Interactive comment on “Effects of terracing on soil water and canopy transpiration of Chinese pine plantation in the Loess Plateau, China” by H. Zhang et al.

Received and published: 6 July 2016

Fig. 1.

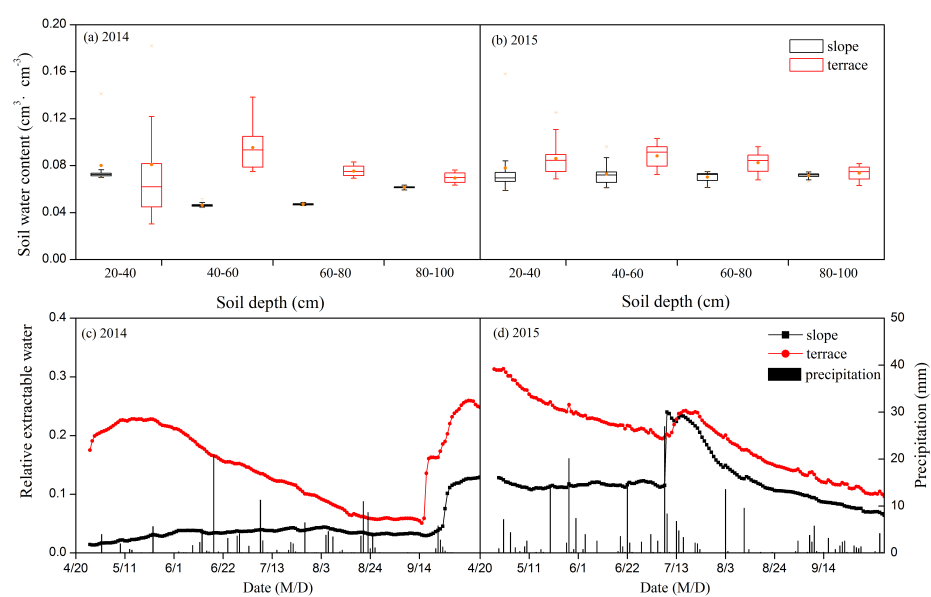
Comment 13: Figure 1 could be removed

Response: As suggested, we moved it to supplementary materials.
